VOICE CONNECTING ARRANGEMENT RCZ CONNECTING ARRANGEMENTS RTT AND RC1 AND 4-WIRE SERVICE KS-19645 TYPE RECORDER CONNECTOR

1.001 This addendum supplements Section 463-340-120, Issue 4.

Fig. 29—KS-19645, List 6 Recorder Connector

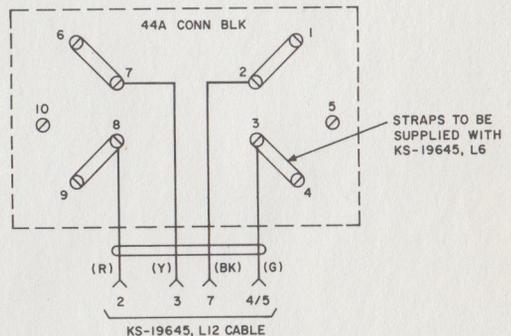
2.003 On page 7, following KS-19645, List 11 Network (Fig. 4), add:

KS-19645, List 6 Recorder Connector

- The KS-19645, List 12 cable has been developed for use with the KS-19645, List 2 recorder connector to allow the customer to terminate his interface leads on screw terminals rather than on the Cannon plug. See Fig. 29.

2.004 On page 14, at the end of the Connection Index listing, add: Fig. 29—KS-19645, List 6 Recorder Connector.
